Re: Response to T.G Miller dated November 9, 2017; Dryden Road Solar Farm

We have reviewed the second round of comments regarding our application, as provided by T.G. Miller on November 9, 2017. Please find below and attached our responses.

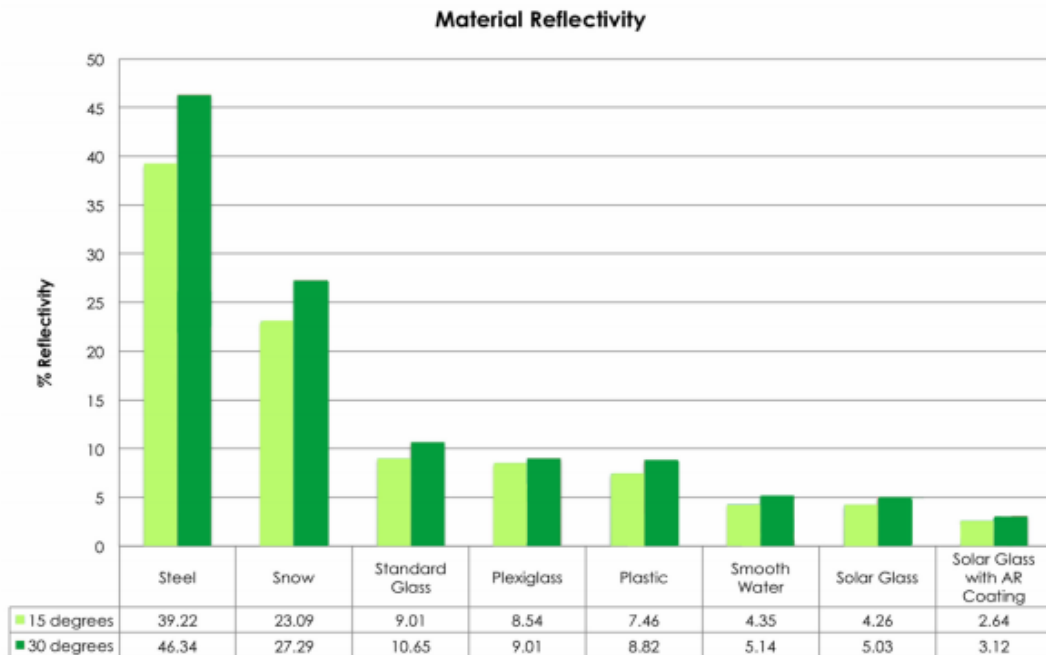
15. **Incorporate a commitment and requirement to mitigate glare, if any, that is realized from**

within the existing residential structures that immediately adjoin or are in close proximity to the solar array property boundary. This would require the applicant to install additional vegetative screening of the species and height needed at appropriate line-of-sight locations to intercept the glare. The term of this condition should be at least five years following the date the arrays are fully operational.

Response: DRS’ vegetation and screening plan incorporates mitigation of glare and we do not anticipate any residences having any material issues with glare from the projects based on the panel orientation and location of nearby homes. Please see Section 4.1.3 of our Project Memorandum for further discussion on glare.

The amount of glint and glare produced from a solar PV system will vary according to the angle of the panels, with lower angles producing less glint and glare. This is illustrated in the below graph, the figures for which were taken from a technical report produced by SunPower (SunPower Solar Module Glare and Reflectance, 2009).

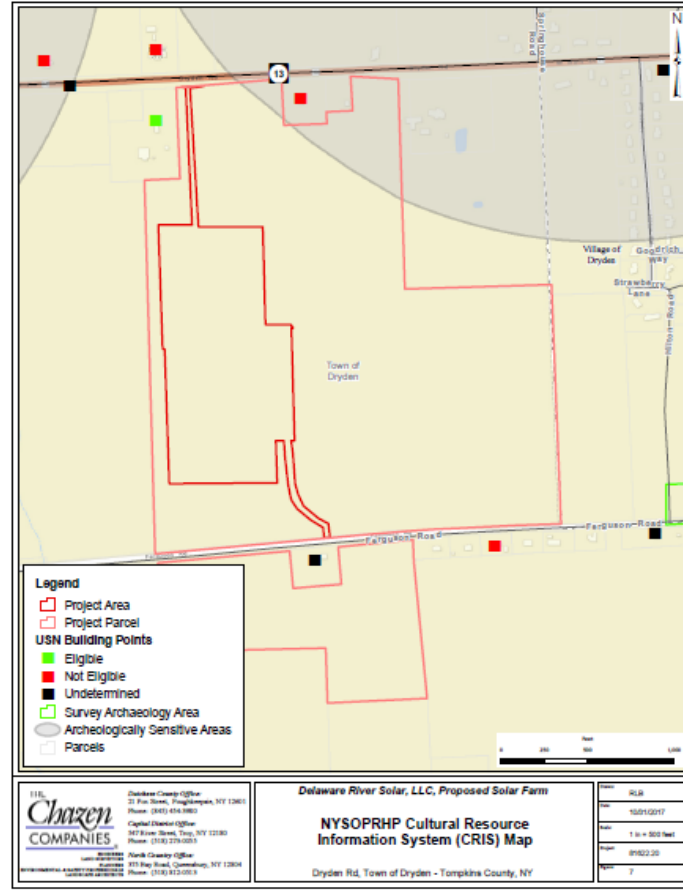
19. Provide an official confirmation letter from NYSOPRHP that the project will not have an impact on historic or archeological resources.

Response: Based on DRS’ site assessment, there is no impact on historic or archaeological resources, please see CRIS map below. A confirmation letter from the NYSOPRHP has been requested and will be provided to the Town when received.
